## PM8200,PS17, Date: 16-July-2002 Model: SR8200,SR9200 marantz<sup>®</sup> Page: 1/1 REF.NBR: MZ02-013 **SERVICE** BULLETIN Subject: Circulation: Application: In correct a RELAY part was used. x for information customer complaint in case of service mandatory See Below ...... Int.ref:

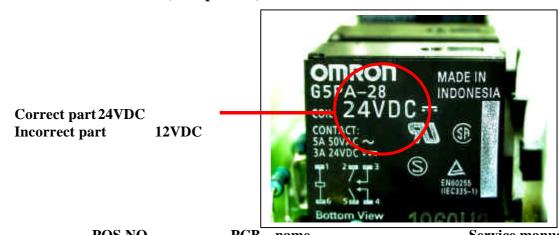
Incorrect parts mixed and were used.

Please exchange for the correct the part.

Correct part no 9965 000 05895 (PCS part no) LY20240490 (MJI part no)
